Subject: Firmware Release Note: Stacker_LOIRE1		Prepared by: T. Tadokoro	
From: PPBG QA/Service Planning Dept.			
Classification:	<input type="checkbox"/> Troubleshooting <input type="checkbox"/> Mechanical <input type="checkbox"/> Paper path <input type="checkbox"/> Product Safety	<input type="checkbox"/> Part information <input type="checkbox"/> Electrical <input type="checkbox"/> Transmit/receive <input checked="" type="checkbox"/> Other ()	<input type="checkbox"/> Action required <input type="checkbox"/> Service manual revision <input type="checkbox"/> Retrofit information <input type="checkbox"/> Tier 2

Model: High Capacity Stacker SK5010		Date: 04-Des-09	No.: RD447003
Subject: Request for Replacement of Parts Containing RoHS Restricted Substances		Prepared by: K. Tsutsui	
From: PP Service Planning Department 1G			
Classification:	<input type="checkbox"/> Troubleshooting <input type="checkbox"/> Mechanical <input type="checkbox"/> Paper path <input type="checkbox"/> Product Safety	<input type="checkbox"/> Part information <input type="checkbox"/> Electrical <input type="checkbox"/> Transmit/receive <input checked="" type="checkbox"/> Other ()	<input type="checkbox"/> Action r

15.Paper Cart Section (D447)

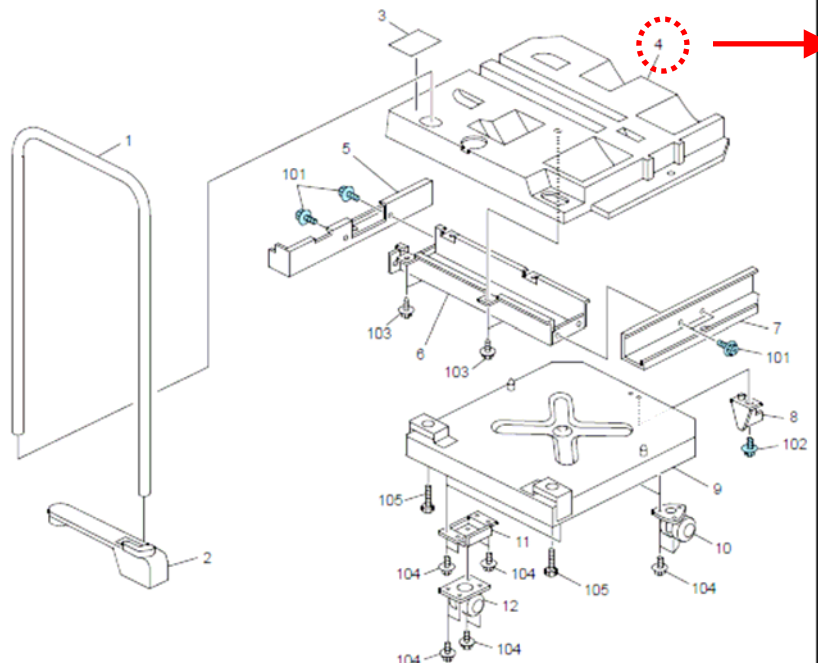
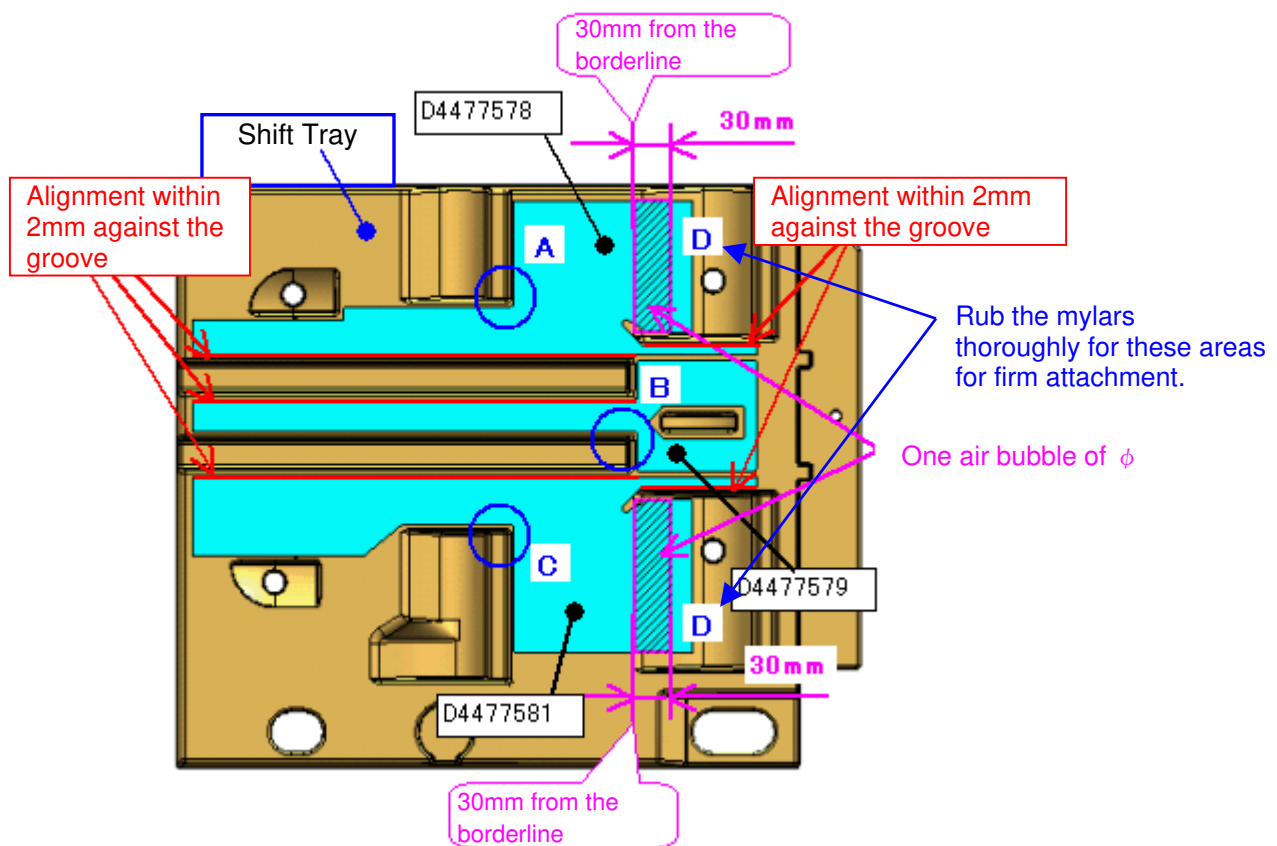
Change: New mylars added for the shift tray

Static electricity could cause the first sheet to stick to the shift tray of the Stacker (indexed 4 in the diagram below) and the succeeding sheets to curl up. Three mylars have been added to discharge static electricity for better stacking.

- Wipe the area with alcohol before attaching the mylar.
- Work carefully to avoid air bubbles. If air bubbles cannot be avoided, the only areas permissible are the two areas indicated in pink in the diagram below.
- Align the corners "A", "B", and "C" so that the edges are positioned within 2mm from the grooves.
- The curved areas "D" should be double-checked. Rub the mylars thoroughly for firm attachment.
- Wipe the surface of the mylars with alcohol to complete the procedure. (Make sure alcohol does not leak in between the mylar and the tray.)

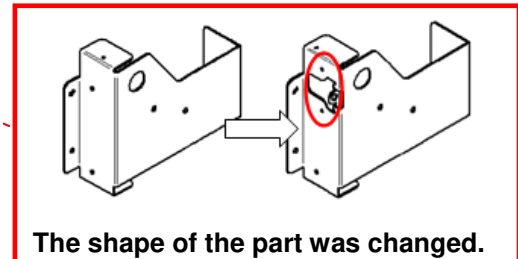
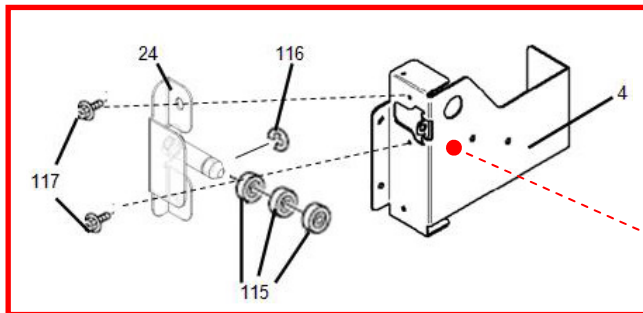
Note 1. The shape of the part was changed

17.Drive Section 2 (D447)

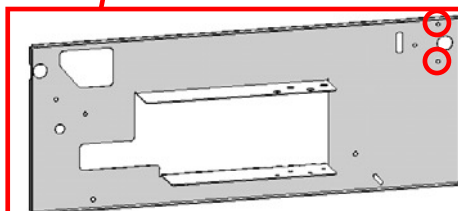
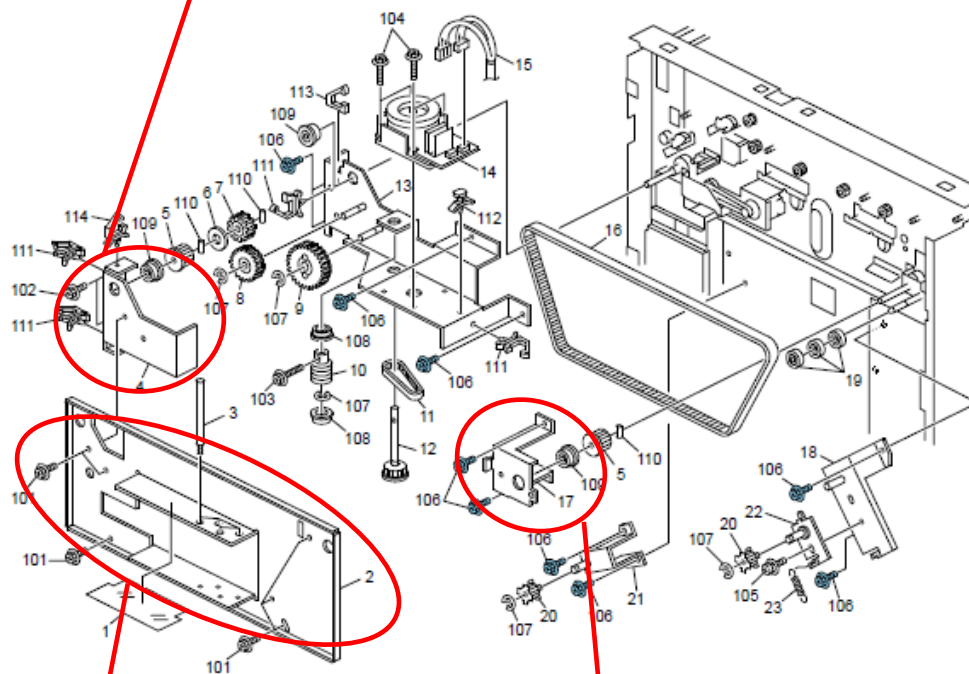
The shape of the part was changed.

The two screw holes were added.

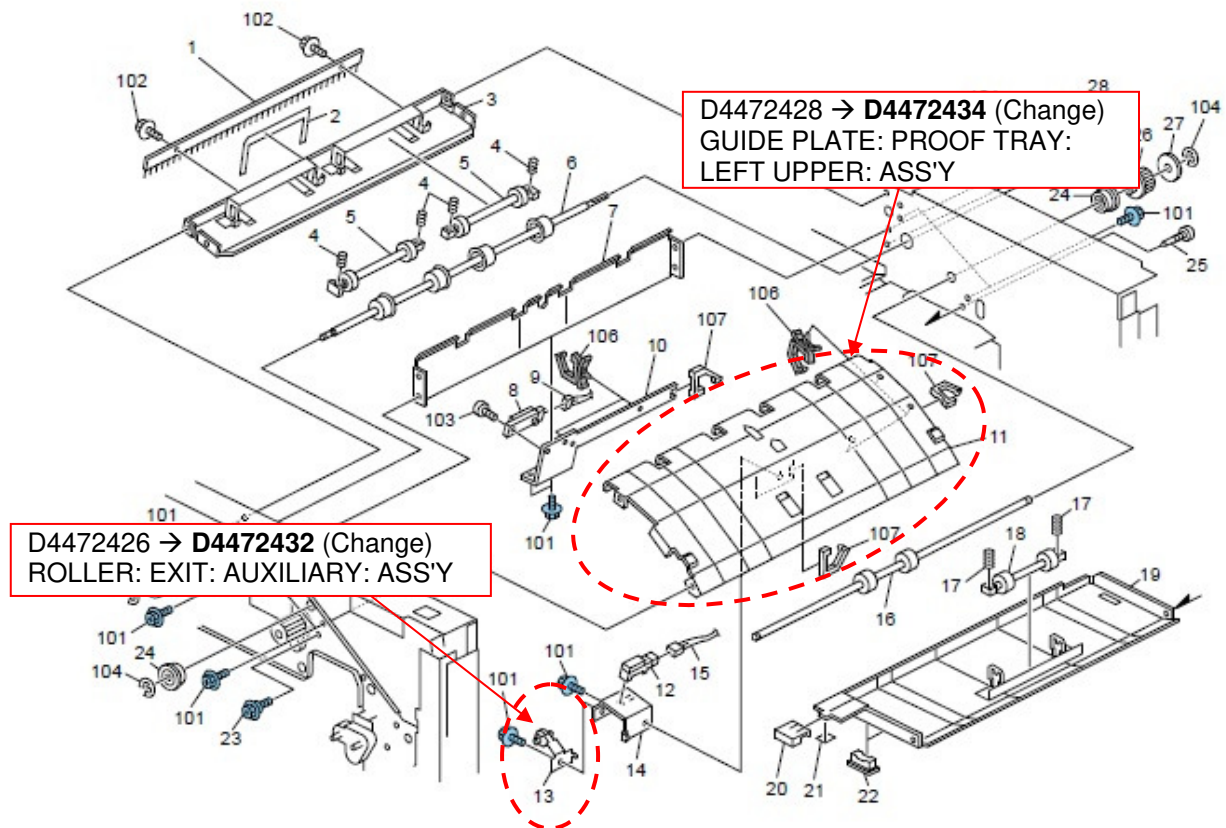
Change: Shapes of the Guide Plate and the Roller of the Proof Tray

Note 2: GUIDE PLATE: PROOF TRAY: LEFT UPPER: ASS'Y has been modified as follows: D4472421 → D4472428 → D4472434.

Note 1: When replacing the above parts, replace D4472434 and D4472432 as a set.

ROLLER: EXIT: AUXILIARY: ASS'Y has been modified as follows:
B4782231 → D4472426 → D4472432.

6.Proof Tray Exit Section (D447)

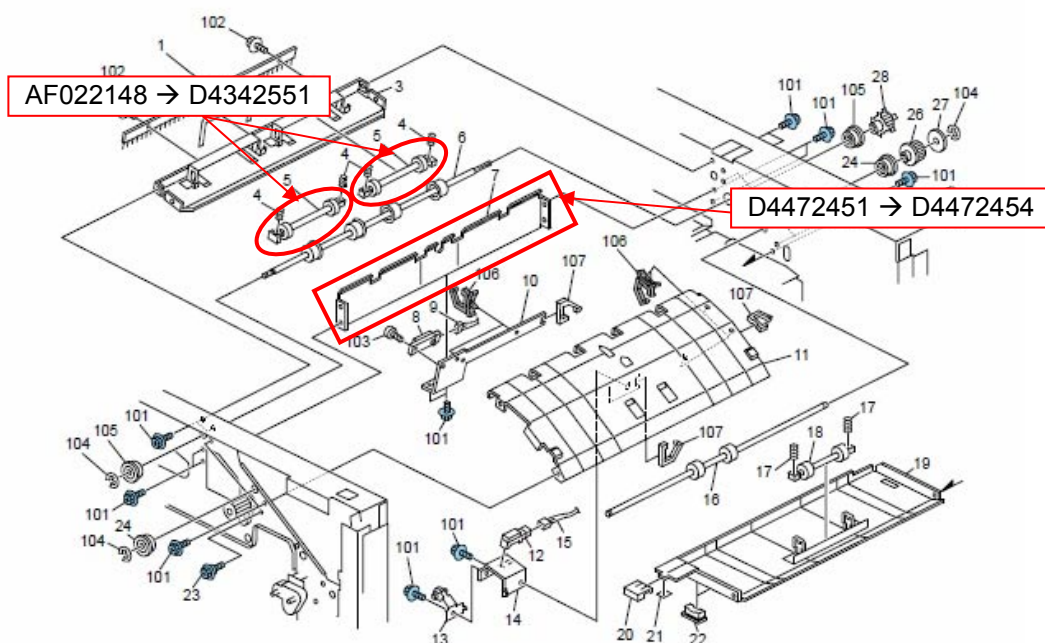
Change: Rollers that feed out paper to the Shift tray and the Proof tray were modified.

Old Part Number	New Part Number	Description	Q'ty	Int	Page	Index	Note
AF022148	D4342551	EXIT ROLLER:DRIVEN: PROOF TRAY:ASS'Y	2	X/O	13	5	-
-	AA080237	BUSHING - 4X5X7	4	-	13	29	Add
D4472451	D4472454	GUIDE PLATE:END FENCE:PROOF TRAY	1	X/O	13	7	-

When replacing any of the above parts for the first time, replace as a set along with the following parts that were announced in RTB RD447008:

9.Paper Tray Exit Section (D447)

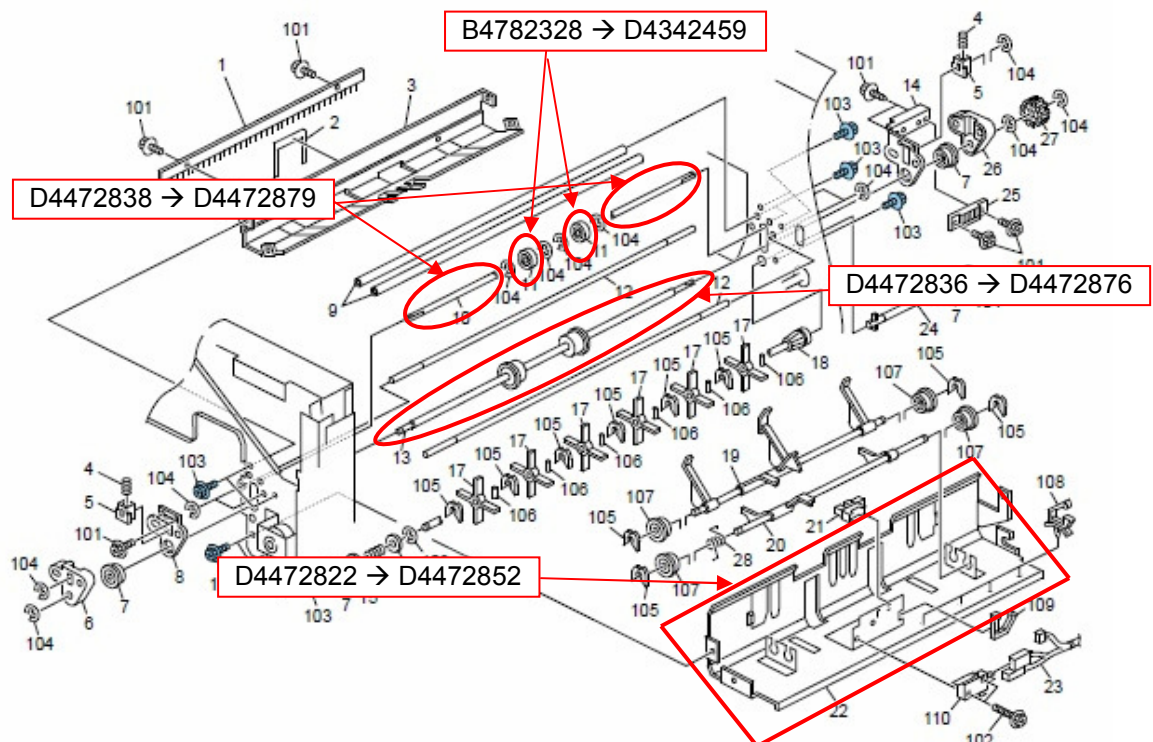
Old Part Number	New Part Number	Description	Q'ty	Int	Page	Index	Note
D4472836	D4472876	EXIT ROLLER:SHIFT:ASS'Y	1	X/O	19	13	-
-	D4342474	ROLLER:EXIT ROLLER:SHIFT	2	-	19	30	Add
-	D4472877	SHAFT:EXIT ROLLER:SHIFT	1	-	19	29	Add
-	06330120G	PARALLEL PIN - 3X12	6	-	19	31	Add

Old Part Number	New Part Number	Description	Q'ty	Int	Page	Index	Note
D4472822	D4472852	END FENCE:SHIFT:ASS'Y	1	X/O	19	22	-

1.Exterior 1 (D447)

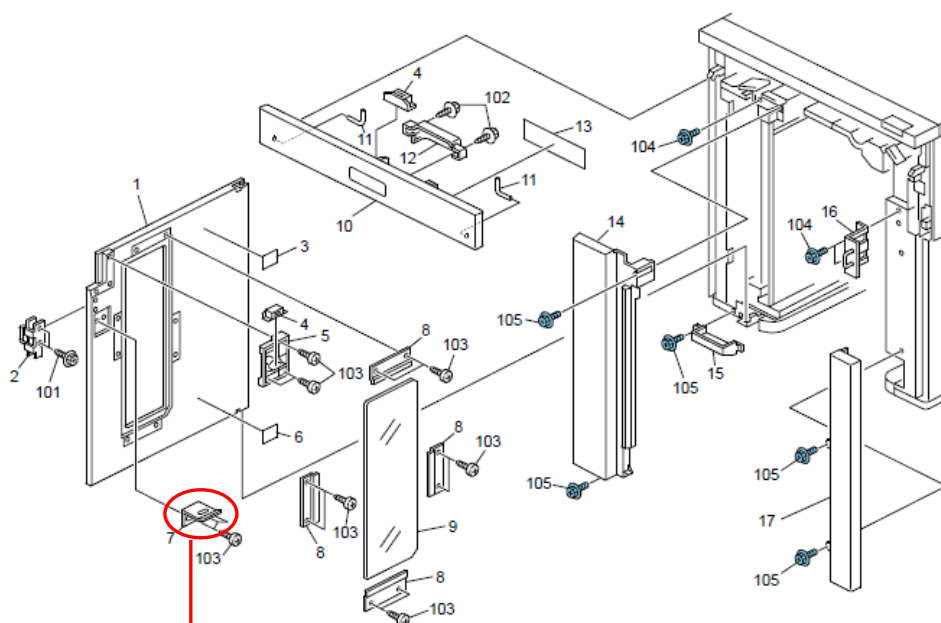
Change 1: The door-lock bracket was modified.

D447 6143 → D447 6150

21. Electrical Section 3 (D447)

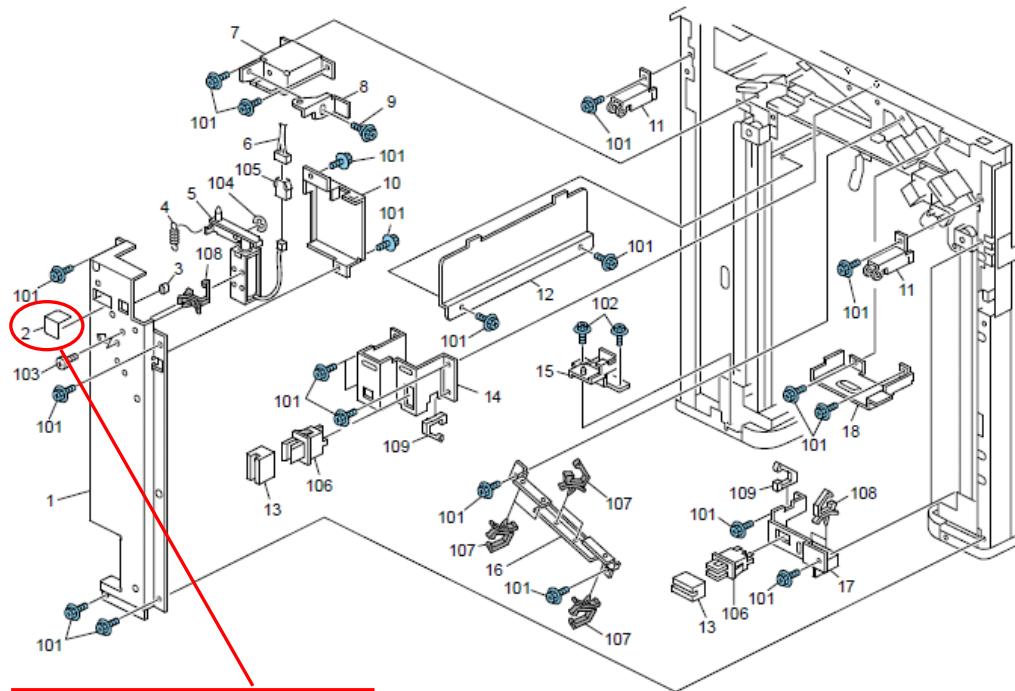
Change 2: The Mylar Sheet attached to the door-lock bracket was eliminated.

D447 1178 → Deleted

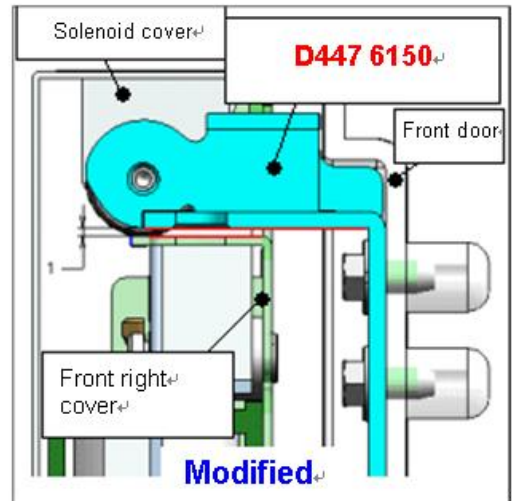
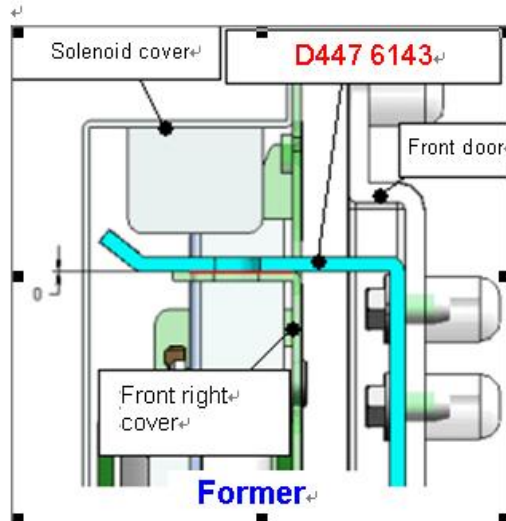
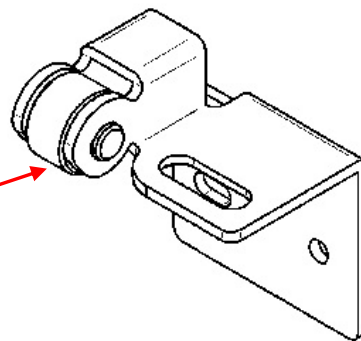
Opening and closing the front door many times could cause the Mylar Sheet, which is attached to the door-lock bracket to prevent friction between the door bracket and the mainframe bracket, to come off over time. When the Mylar Sheet comes off, the double-sided adhesive tape remains on the bracket, and causes the door to jam.

This photo shows the Bracket missing the Mylar Sheet, leaving only the double-sided adhesive tape.

As a substitute for the Mylar Sheet, the modified Bracket incorporates a roller to reduce the friction between the brackets.

Picture: SHEET: DOOR: LOCK

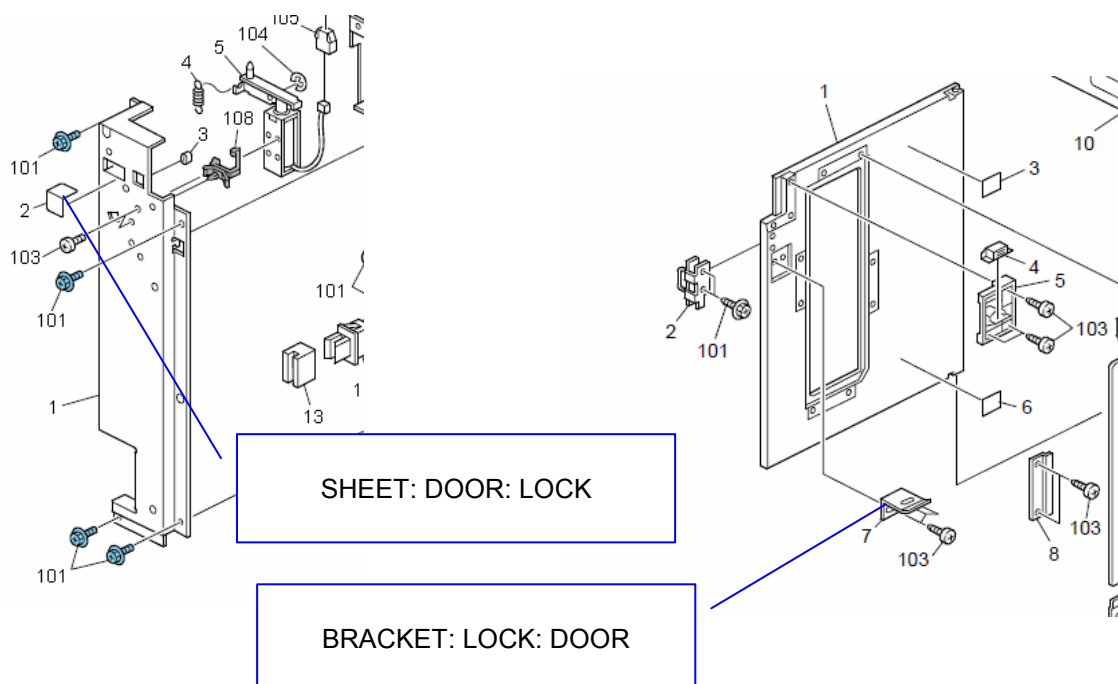
- Removing mylar sheet
- Adding the pressure roller to the door lock bracket

There is a possibility that the mylar sheet of the Door Lock Component is easily stripped after a certain time use. To prevent this, a pressure roller is added to the door lock bracket and that mylar sheet is removed.
